Period of Omission of Data during Gear Changes

Proposed Modification of the gtr Draft

*** Condition of data omission**

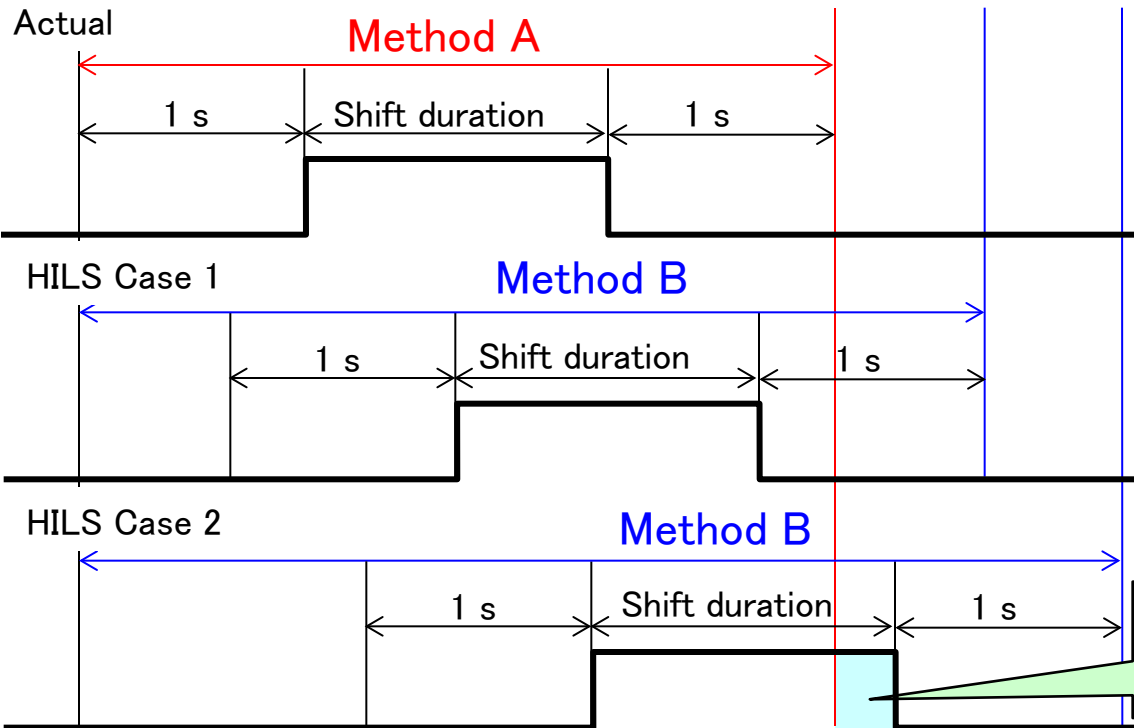
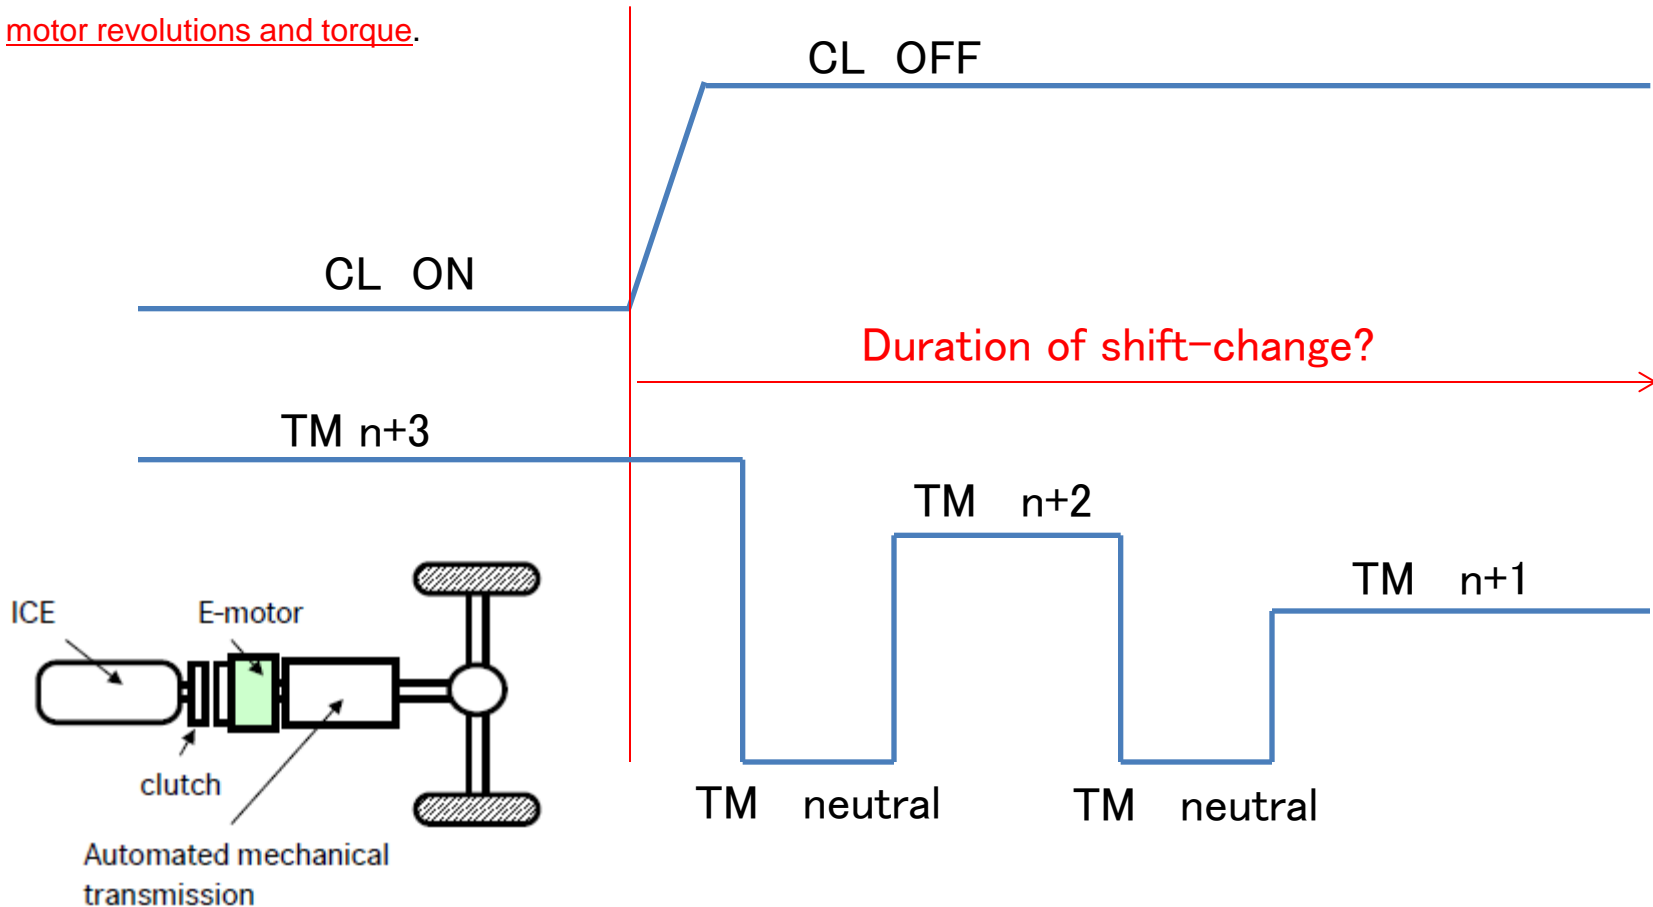
- Method A: Define the period of omission as duration of gear change in the “value actually measured in validation test” or “value in HILS simulated running”, plus one second before and after the change.

- Method B: Define the period of omission as duration of gear change in the “value actually measured in validation test” and “value in HILS simulated running”, plus one second before and after the change.

HILS Case 1: The duration of gear change in the value in HILS simulated running is included in the value actually measured in validation test plus one second before and after the change.

HILS Case 2: The duration of gear change in the value in HILS simulated running is wholly or partly excluded from the value actually measured in validation test plus one second before and after the change.

*** HILS Case 1:**
- There will be no significant difference whether Method A or B is adopted

*** HILS Case 2:**
Method A: Likely to weaken the correlation between the value actually measured in validation test and the value in HILS simulated running.
Method B: Lengthens the period of omission. Reduces the number of specimens for validation (in particular for vehicles with many gears, like those with 12 gears)

Considering the number of specimens for validation, it is better to adopt Method A.

3. Response to Some Particular Gear Change Systems (2)

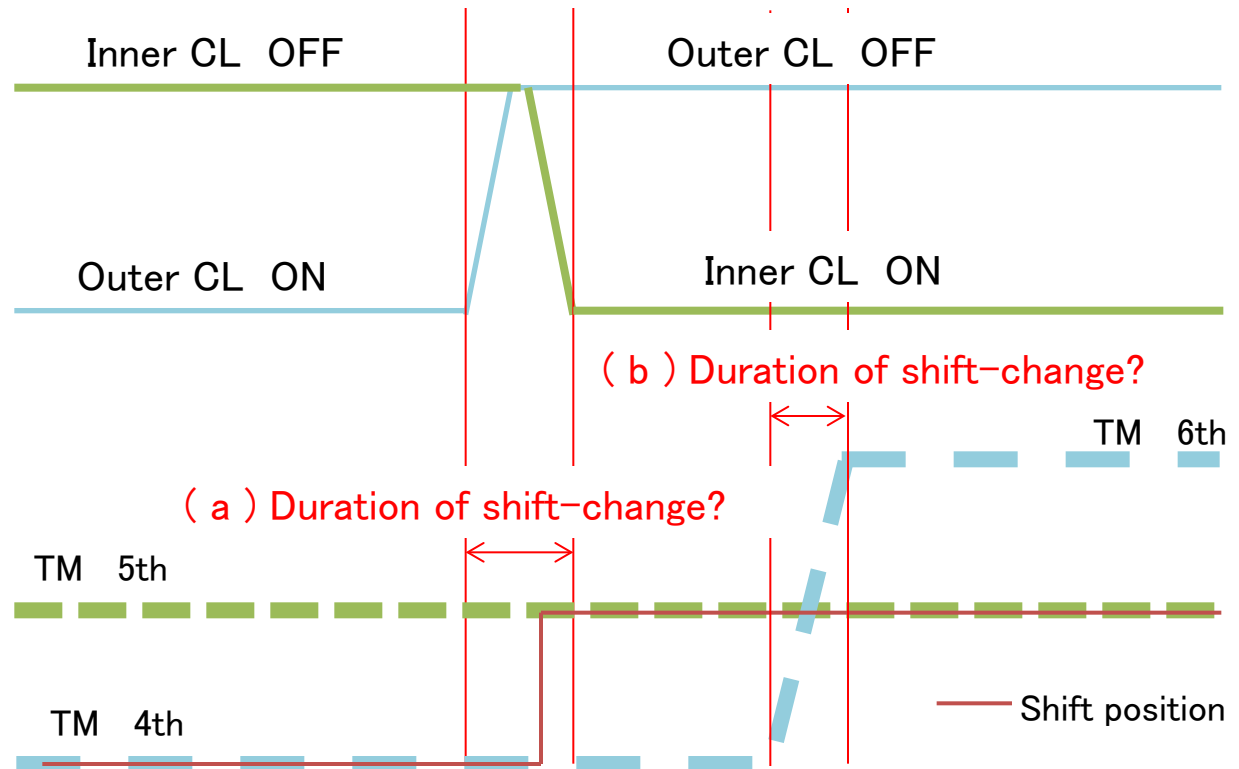
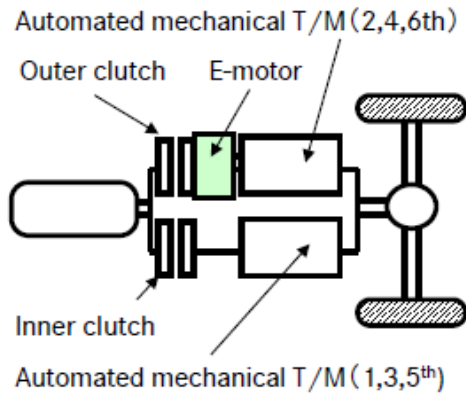
Since HEV with dual-clutch transmission systems have multiple clutches, we need to specify which clutch is the one being considered for the duration of gear change “from clutch disengagement to clutch engagement”. Considering the influence on the engine, it would be better to regard that “the clutch is engaged” if any of the multiple clutches is engaged ((a) in the figure below).

Further, the question arises also as to how we should handle change systems that don't need disengagement and engagement of the clutch ((b) in the figure below). We find it necessary to include them in the period of omission because, while not influencing the engine revolutions and torque, they do influence the motor revolutions and torque.
